AMENDMENT 3

REQUEST FOR PROPOSALS UOG RFP No. P22-02

"DESIGN BUILD CONSTRUCTION SERVICES FOR A NEW SCHOOL OF ENGINEERING"

QUESTIONS & ANSWERS SHEET NO. 1

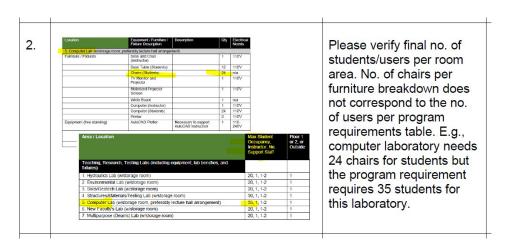
NO.	IMAGE REFEREN	E GUMA REMARKS		
1.	Other Indoor spaces 1. Air compressor room (?) 2. Air conditioning maintenance room 3. Reviation mini, electrical, faite, chains) 4. Communications // Pequipment room 5. Ciscidioan mini, electrical, faite, chains) 7. Revalual maintenance room 8. Entry lathy, shiftmenhalling and, industrial elevator, stanways) 9. Indian are appoint faulting date, industrial elevator, stanways) 10. Shifted room 10. Shifted room 11. Shifted room 11. Shifted room 11. Shifted room 12. Shifted room 13. Shifted room 14. Shifted room 15. Shifted room 16. Shifted room 16	2 1 1 1 1 1 1 1 1 1 1 1 1 1 1 1 1 1 1 1	16.2 1 1 1 1 1 1 1 1 1 1 1 1 1 1 1 1 1 1 1	Kindly clarify this indoor space: inside area opposite loading dock near roll-up back door. Will this be the loading room?

Answer: No, it is just the end of the hallway at the back of the building.

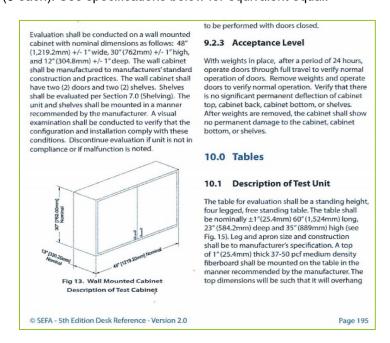
Fumit	ure / Fixtures	Desk and Chair (Instructor)	1	n/a	If possible, please provid
1		Hydraulic Lab Stools (Students)	20	n/a	the type of furniture syste
		Work Station for students	2	n/a	or specifications to
		Counter tops for equipment	4	n/a	consider in the interior
	*	Storage Cabinets	3	n/a	design layout

Furniture for labs should have chemical resistant counter tops, storage cabinets which will house the chemicals needed for the labs as purposed, desk, chairs lab stools and workstation functional for classroom or labs as required.

Hazardous storage cabinets shall be designed so as all chemicals are not storade above shoulder height with the over all cabinet height of not more than 65". These cabinets shall be in an area of the laboratory with low traffic away from the main work area. Tall cabinets shall be secure to walls and provide seismic anchorage as required per Guam code.

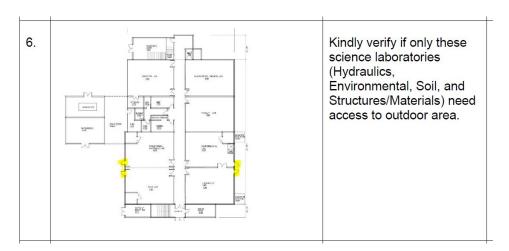
Question 6:

For security and long-term durability, UOG desires that all laboratories are exited through the double doors into the central hallway on the first floor. Those double doors need to be wide enough to allow for large equipment to be brought into the laboratories and classrooms.
